GLOBAL SAFETY FIELD INVESTIGATIONS
DCS5711
URGENT - DISTRIBUTE IMMEDIATELY

Subject: N212329850 - Customer Satisfaction Program
Control Box Circuit Breakers

Models: 2019 – 2021 Chevrolet Silverado 4500HD/5500HD/6500HD
Equipped with Provisions Electrical Switch Bank SEO (RPO UEH)

N212329850 Control Box Circuit Breakers

5753962

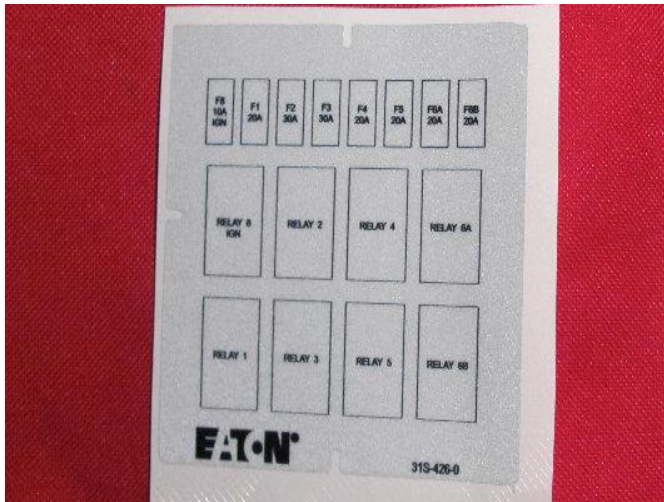
3. Locate the eight circuit breakers on the left side of the power distribution block.

CB8 (CB 5Amp) will get 10Amp fuse GM PN 12092079
CB1 (CB 20Amp) will get 20Amp fuse GM PN 88861352
CB2 (CB 30Amp) will get 30Amp fuse GM PN 12092075
CB3 (CB 30Amp) will get 30Amp fuse GM PN 12092075
CB4 (CB 20Amp) will get 20Amp fuse GM PN 88861352
CB5 (CB 20Amp) will get 20Amp fuse GM PN 88861352
CB6A (CB 20Amp) will get 20Amp fuse GM PN 88861352
CB6B (CB 20Amp) will get 20Amp fuse GM PN 88861352

4. Install fuses in the locations shown above. All of the fuses are the same amp rating as the removed circuit breaker except for position CB8. The CB8 position 5-amp circuit breaker gets replaced with a 10-amp fuse.
5. Clean the inside surface of the fuse block cover with isopropyl alcohol.

5774684

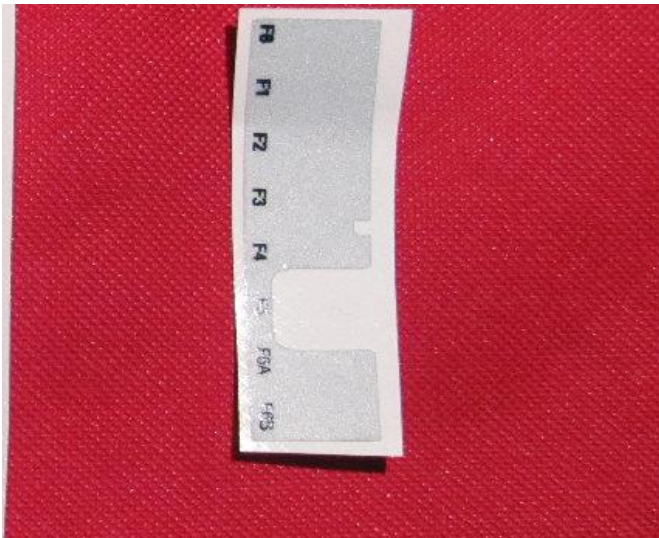
6. Install the fuse block cover label as shown. Carefully separate the label from the backing paper, do not touch the adhesive.
